Response to Submissions and Amendments to Proposed Development

Sydney International Convention, Exhibition and Entertainment Precinct

Submitted to Department of Planning & Infrastructure
On Behalf of Darling Harbour Live

June 2013 ■ 12811

Figure 4 – Existing and proposed useable public space

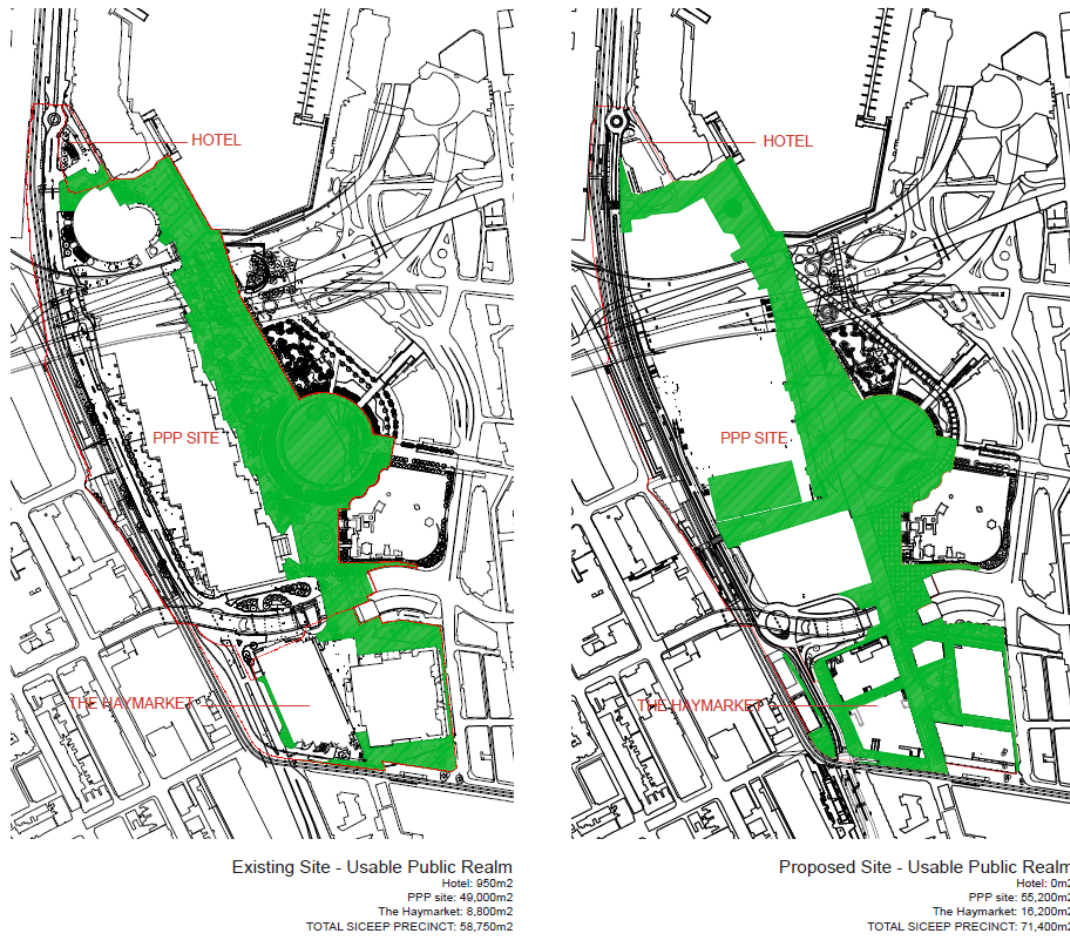
In response to the Department's submission, DHL has quantified the existing and proposed areas of 'useable public space' across the precinct. As shown in **Figure 4** and **Appendix K**:

- The folded landscape is included in the measurement as although some areas are too steep to be physically accessed, it plays an important role in generating the experience of space for the occupiable ramps, paths, balconies, and decks that traverse this landscape. It also adds to the general greenery and character of the Precinct.

Figure 5 – Tumbalong Green – Area comparison

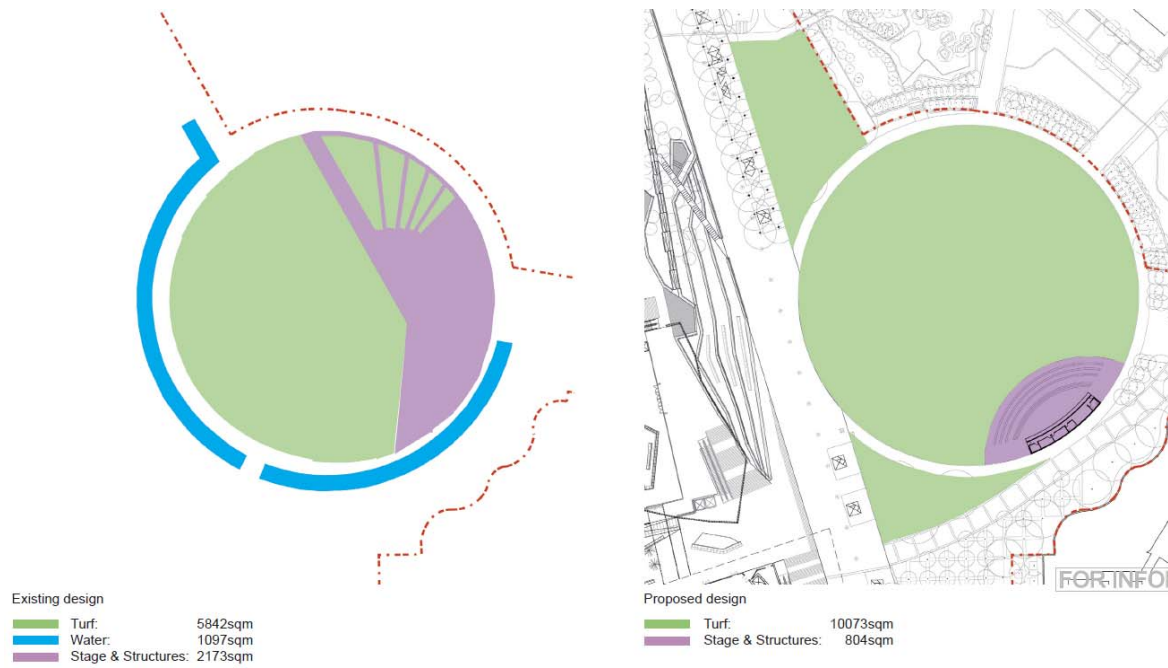
In addition, DHL has calculated the existing and proposed areas within Tumbalong Green (refer to **Figure 5**). They demonstrate that the turfed and staged area will increase substantially from approximately 8,000m² to 11,000m², an increase of approximately 27%. Further, the design of the space has been simplified and flattened to be more functional. Tumbalong Green will now be able to accommodate activities ranging from family picnics and social grass sports to theatrical and major festival congregations.

Figure 6 – Proposed changes to Tumbalong Green overlay

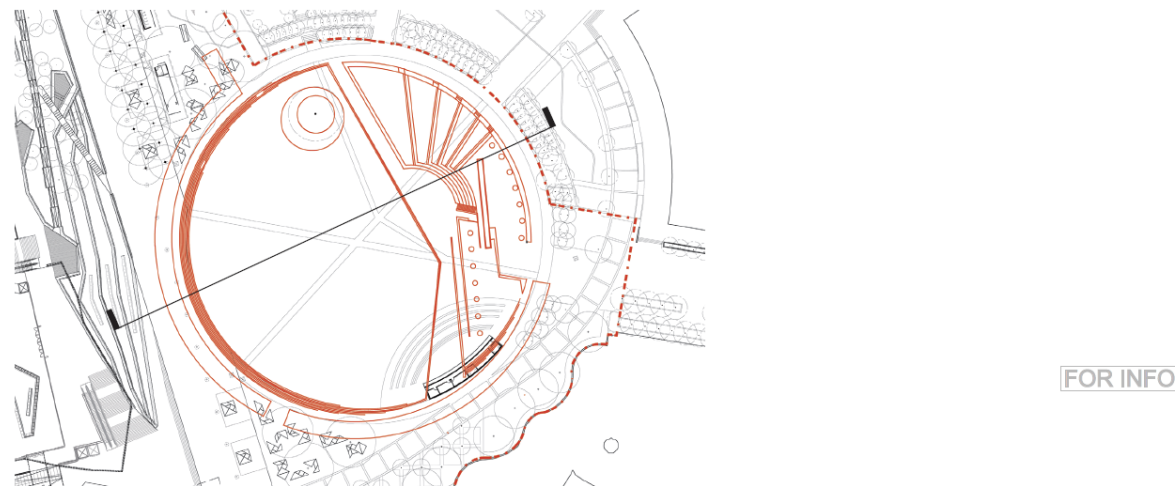
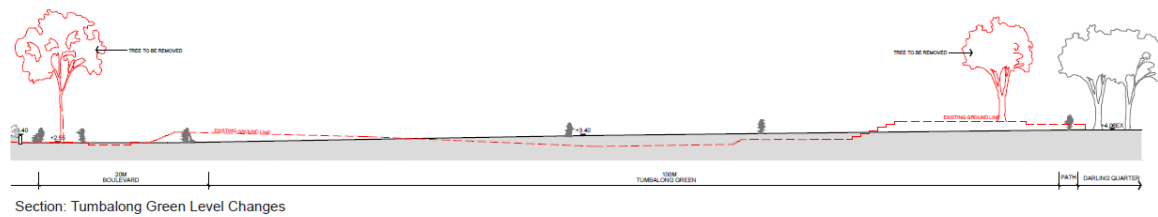
Figure 6 details the proposed functional improvements to Tumbalong Green, and provides a section showing the proposed level changes.

Figure 7 – The Boulevard activation, including retail locations

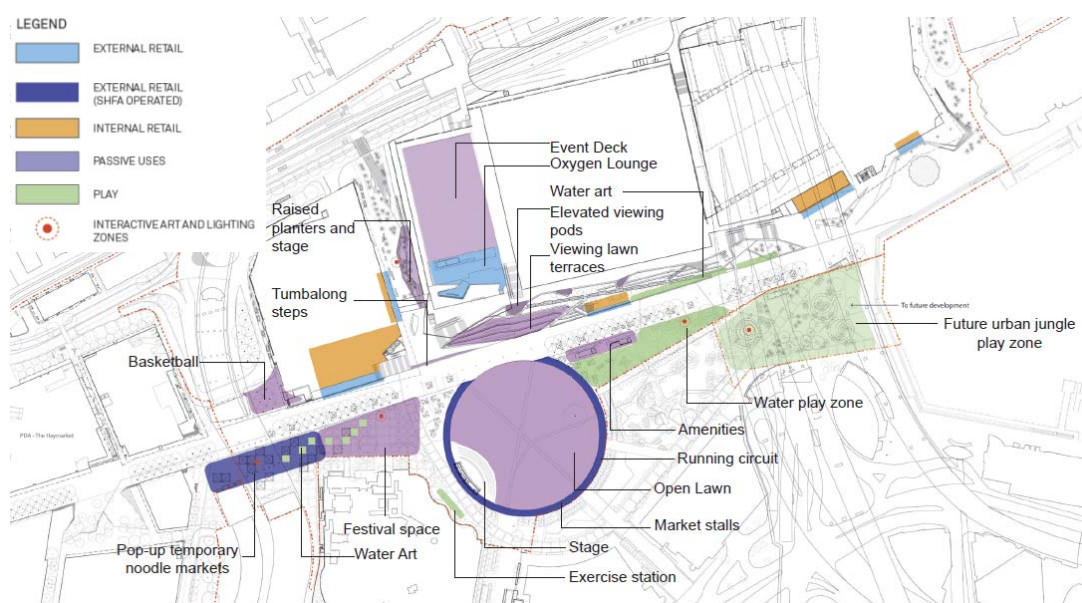
In response to the requests for clarification around the type and extent of retail proposed, it is anticipated that the retail will predominantly comprise food and beverage offers with associated outdoor dining areas. The retail will be at grade level of the Boulevard and will be provided in the locations shown at **Figure 7**.

As shown in **Figure 7** active uses along The Boulevard have been considered holistically. More than 50% of the Theatre has retail frontage, a portion of the Terraced Landscape includes a retail space and around 50% of the ICC that addresses The Boulevard at grade is retail, including outdoor dining. In addition to the proposed retail activation, The Boulevard and edge areas includes a combination of other features including 'water-art', lawn terraces for sitting, interactive information and wayfinding kiosks, noodle markets, Chinese Garden Plaza festival space, half-court basketball facilities, amenities, picnic facilities and the multi-program Tumbalong Green, which includes gym facilities. A future proposal being considered outside of the subject DA boundary is the 'urban jungle', which would be a play zone for older children and young adults.

Figure 11 – Pedestrian networks

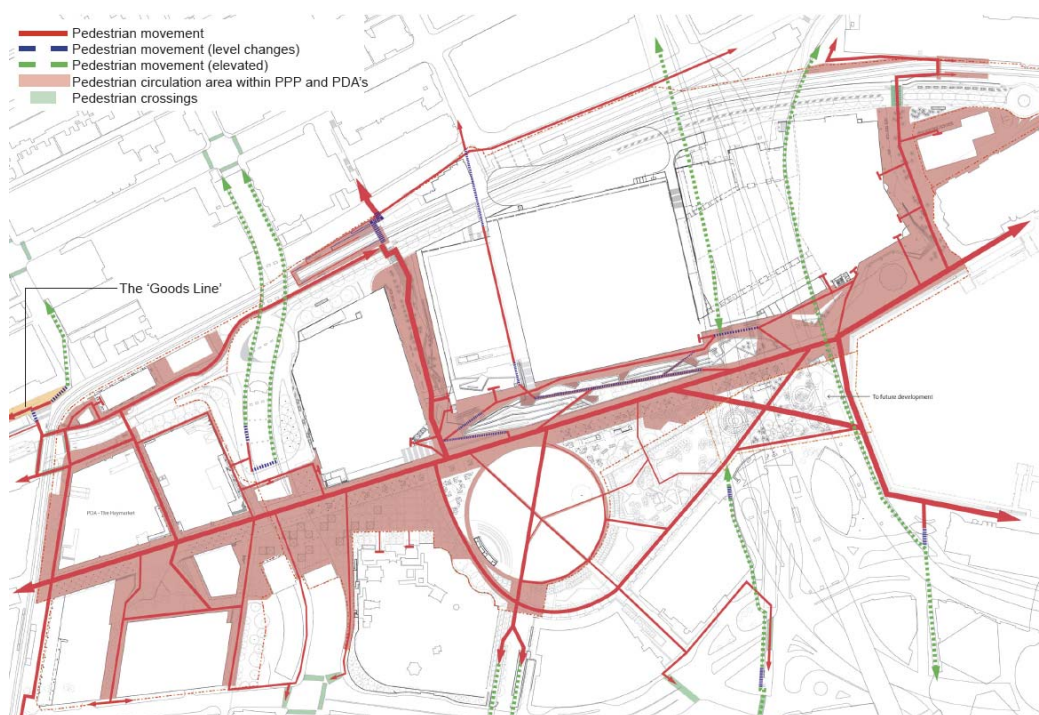
The Department has requested that a detailed pedestrian network plan be provided showing connectivity between the precinct and the surrounding network. The Department has also requested further details around how pedestrian flows will be managed prior to and following large events, particularly at key pedestrian / vehicle conflict points along Darling Drive, and have asked for additional details to demonstrate that the size and scale of pedestrian paths across Tumbalong Green will be adequate to cater for projected volumes of people travelling to and from Town Hall Station during event mode. The Department also put forward various options for consideration for managing pedestrian safety and cycle / pedestrian / vehicle conflicts and requested further details around the interaction of these groups.

HASSELL has prepared a series of diagrams addressing the pedestrian accessibility issues raised by the Department. A full set of diagrams is provided at **Appendix K**. **Figure 11** shows the various pedestrian connections across the site and to surrounding areas, demonstrating an appropriate level of accessibility and connectivity with surrounding pedestrian networks. The proposal greatly improves the east-west connectivity into the precinct, and a footpath has not been provided along the eastern side of Darling Drive as it is not DHL's intention to promote north-south access along the eastern side of Darling Drive.

Figure 12 – Tumbalong Green pedestrian networks

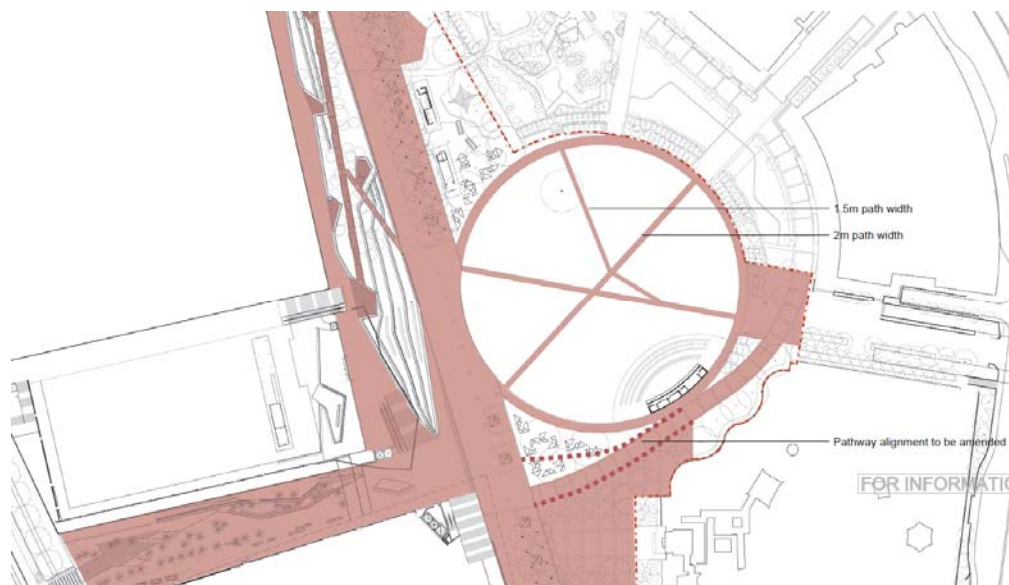
Many of these concerns, including the capacity of pathways across Tumbalong Green, were reiterated by Council. In addition, Council requested that the southern pathway around Tumbalong Green be given its own geometry, and be widened at The Boulevard to cope with likely pedestrian demands. Council also requested that the Pier Street underpass be transformed, stating that a design competition should be held in relation to the comprehensive refurbishment of the Pier Street pedestrian and vehicle underpass. Council also stated that the Convention Centre drop-off should be reconfigured to provide pedestrian primacy.

The footpath alignment and pathway geometry in and around Tumbalong Green has been amended to address the concerns raised by the Department and Council, as shown in **Figure 12**. Whilst DHL has considered widening the paths to cater for people movements in large events, this would change the character of the Green, and would mean that it was defined by the paths instead of green space which is its primary role. Further, it is considered that primary pedestrian movement from Town Hall into SICEEP will also include the significant circulation zones around Darling Quarter and the Chinese Garden, and not just Tumbalong Green in isolation. As a result, it is not considered necessary to widen the paths for events.

Figure 13 – Convention Centre drop-off

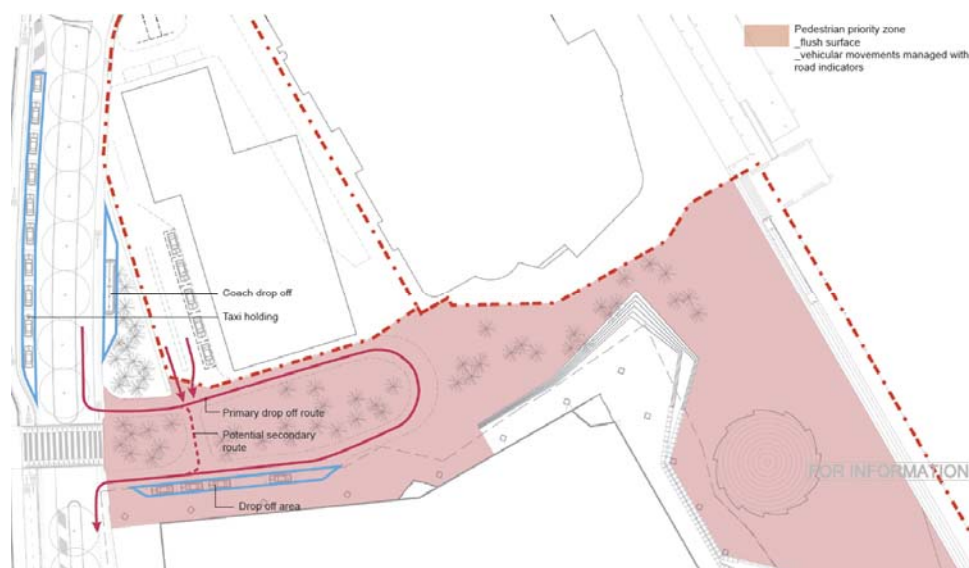
In response to Council's concerns about the Convention Centre drop-off and the need to provide pedestrian primacy, it is noted that in order to meet the INSW Brief DHL are required to provide an 'all-weather' drop off adjacent the entry. The design intent is for this space to read as a continuous pedestrian zone, similar to a Hotel porte-cochere. To strengthen the pedestrian nature of the zone, kerb and gutter is not proposed to be adopted in this area. The ICC drop-off is shown at **Figure 13** and **Figure 14**.

Figure 15 – Cycle strategy

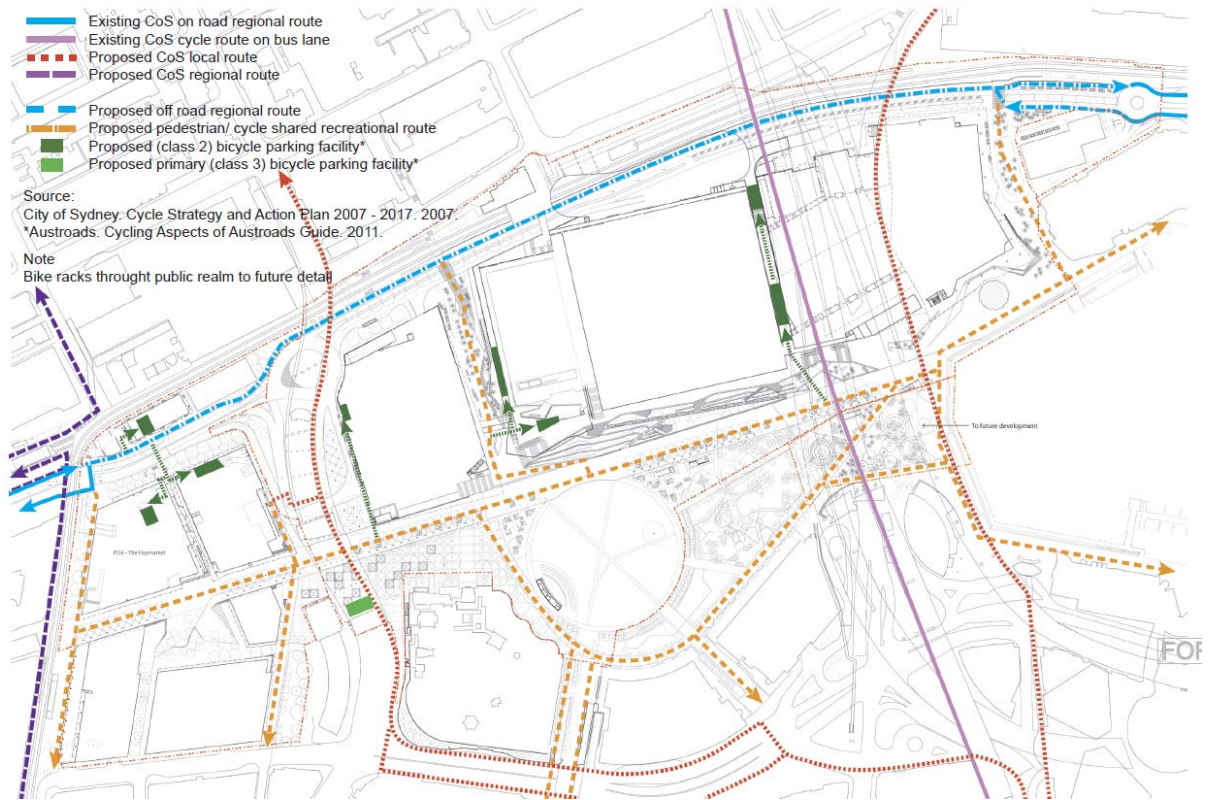
In response to the Department's concern, a detailed cycleway plan has been prepared to show the location of the proposed cycle path and where it connects to the existing cycleway network, as well as pedestrian crossings and paths and vehicular entry / exit points (refer to **Figure 15**). DHL will continue to work with INSW, Council and SHFA through the detail design stage to ensure resolution of potential conflict points.

Figure 16 – Shadow impacts on surrounding residential buildings at 9am on 21 June

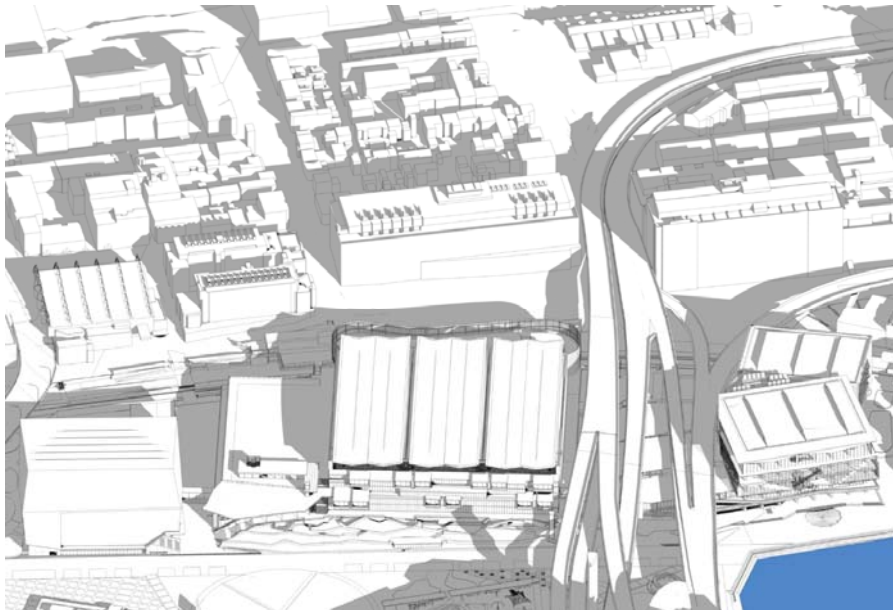
The Department has noted that further information is required to accurately assess shadow impacts to nearby residences and also Tumbalong Park. In this regard, the Department has requested smaller scale shadow diagrams (existing and proposed) which clearly show the extent of overshadowing to residential properties on the western side of Pyrmont Street (Goldsbrough and Bullecourt Apartments) and the public domain (Tumbalong Park).

Axonometric diagrams have been prepared to enable an assessment of the shadow impacts on residential development to the west of Pyrmont Street. The diagrams demonstrate that at 9am on 21 June, there will be very limited overshadowing to the lower levels of the Goldsbrough and Bullecourt Apartments. There will be no overshadowing of these buildings by midday on 21 June. These diagrams are replicated at **Figures 16 and 17** and demonstrate that the proposal will have a negligible impact to the availability of solar access to these apartments, with solar access maintained from 9am onwards in the morning on the Winter Solstice.
